From:
Sent: 20 May 2015 13:45
To:
Subject: RE: High Moor Farm, Beckwithshaw, Harrogate. Ref 15/01718/FUL Your ref 22325
Attachments: 20150520-Coverage Map.doc

Thank you for your letter dated 30 April 2015 setting out your objections to the proposed development of 2 wind turbines at High Moor Farm, Beckwithshaw, Harrogate, North Yorkshire.

DIO 22325 coverage estimate plot for Linton-on-Ouse Watchman (48m, 20.5m² RCS, 235° - 255°, Aux Beam)

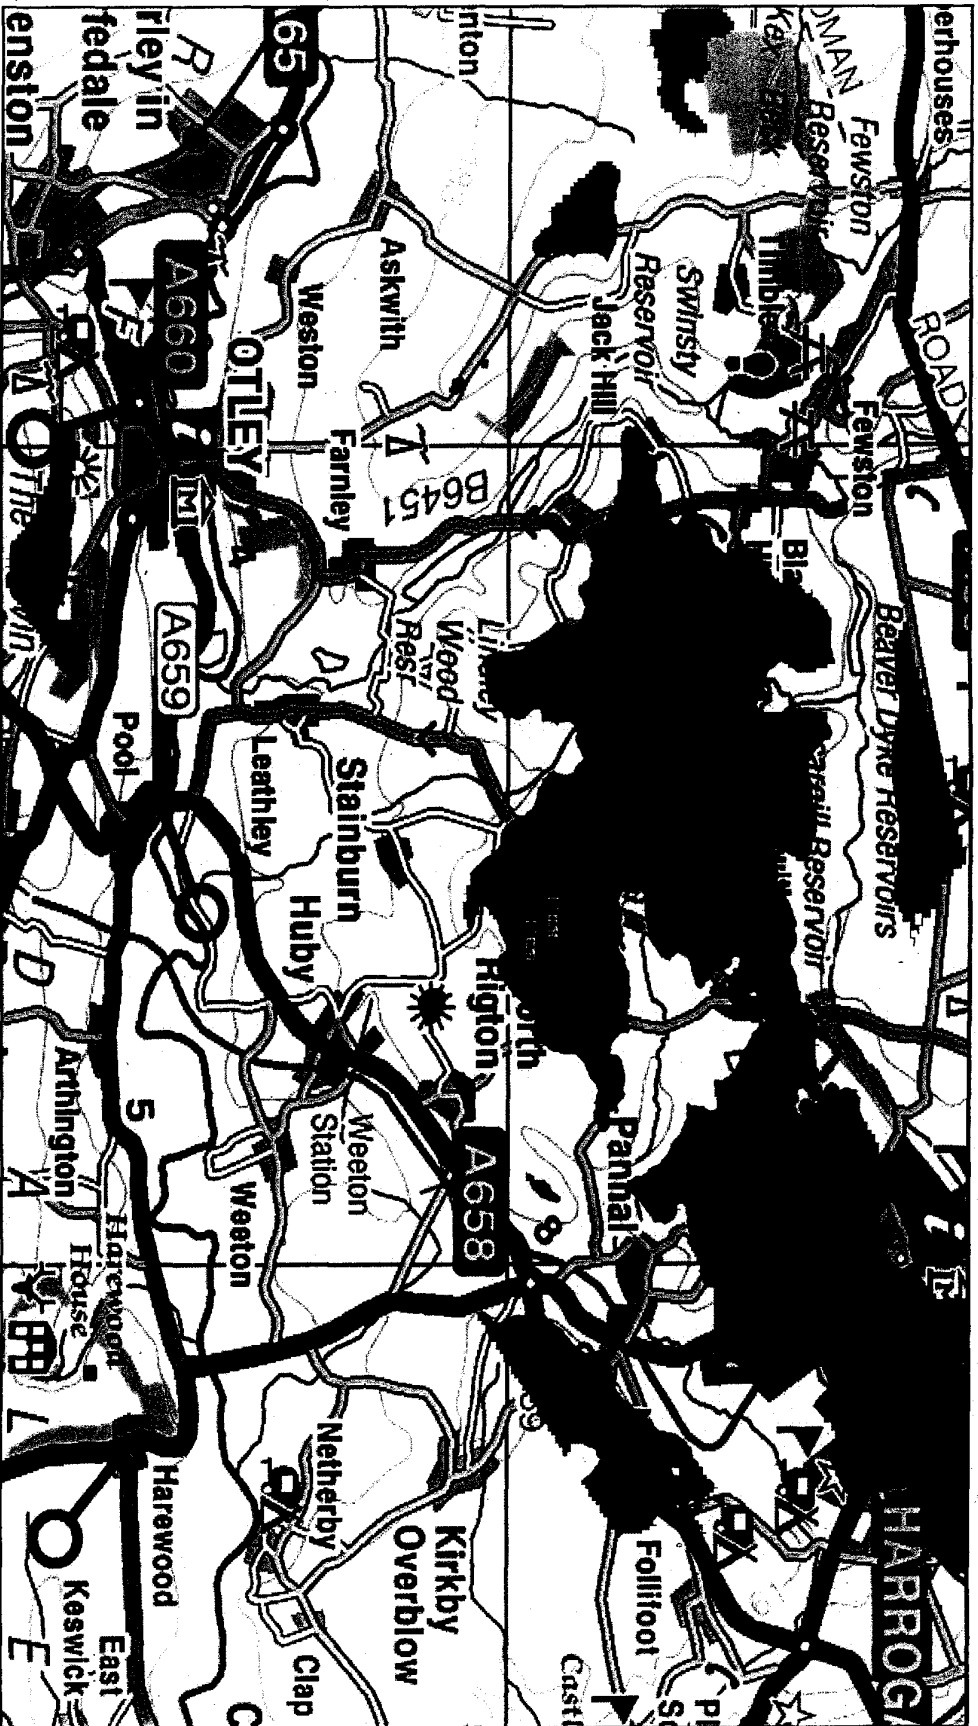
- Have they objected to our recent proposal as it is for 2 turbines, would a single turbine receive an objection? Both turbines are detectable by the radar at RAF Linton-on-Ouse. 43m of the turbines are detectable. I have attached a coverage map for your information.
